MILITARY SPECIFICATION SHEET

CONNECTORS, PRINTED CIRCUIT SUBASSEMBLY AND ACCESSORIES, RECEPTACLE, SOCKET CONTACTS, DECADE INCREMENTS 10 THRU 70 CONTACT POSITIONS AND INTERMEDIATE POSITIONS OF 14, 24, 44, 54 AND 26, 36, 56, 66 FOR PRINTED WIRING BOARDS (.100 INCH SPACING)

This amendment forms a part of Military Specification Sheet MIL-C-55302/65E, dated 26 December 1984, and is approved for use by all Departments and Agencies of the Department of Defense.

FIGURE 2. Socket contact, crimp.

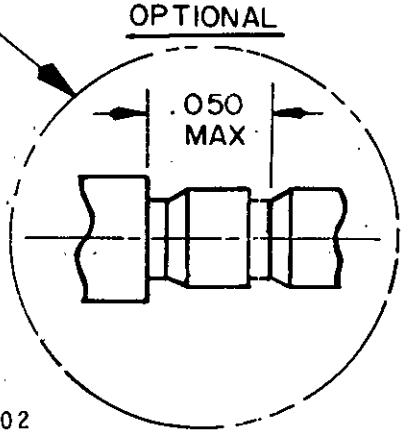
FIGURE 2, delete and substitute new figure 2 as printed on page 2 of this amendment.
